**STATE OF LOUISIANA
BEFORE THE
LOUISIANA PUBLIC SERVICE COMMISSION**

APPLICATION OF ENTERGY)
LOUISIANA, LLC FOR APPROVAL OF)
GENERATION AND TRANSMISSION)
RESOURCES PROPOSED IN) **DOCKET NO. U-37425**
CONNECTION WITH SERVICE TO A)
SIGNIFICANT CUSTOMER PROJECT)
IN NORTH LOUISIANA, INCLUDING)
PROPOSED RIDER, AND REQUEST)
FOR TIMELY TREATMENT)

**Direct Testimony and Exhibits of
Nicholas W. Miller
On Behalf of the
Alliance for Affordable Energy and
Union of Concerned Scientists**

April 11, 2025

Figure 1: example of a data center’s dynamic behavior load

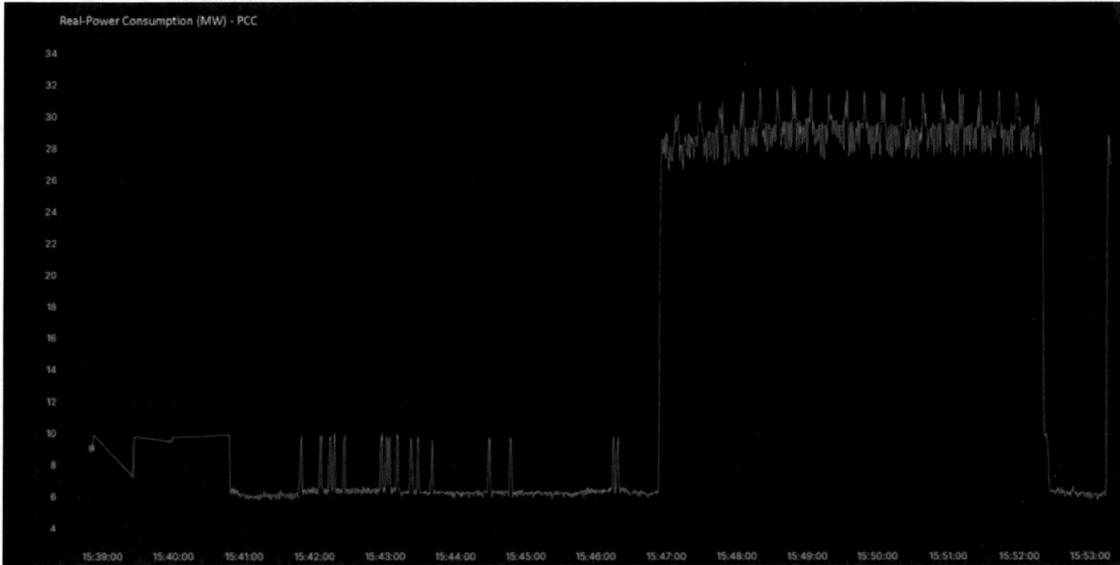
1 An example of this variability is given in Figure 1 below.

As described in the draft working paper, “Practical Guidance and Considerations for Large Load Interconnections,”³⁷ this Figure shows:

... how non-conventional [data center loads] are compared with historical end-use loads, where AI training runs result in extremely intermittent power consumption. Figure [1] shows an example of a 50 MW data center block (the entire facility has four points of connection totaling 200 MW). Active power consumption captured with a microprocessor-based relay high speed data recorder shows power consumption jump from 6 MW to 30 MW in a matter of 290 ms (about one-quarter of a second). Power consumption is then highly variable, with 5 MW spikes, for about 5 mins before returning to low power consumption levels and shortly after

1 returning to high power consumption. Note that this facility is not
2 interfaced with the grid through [an uninterruptible power system],
3 so the power consumption is observed directly on the grid side of
4 the customer interface.³⁸

5 Although the data center represented in Figure 1 is [[REDACTED]] than the one
6 the Customer wishes to build, this Figure provides a general sense of how data center
7 loads can vary significantly over very short periods of time.
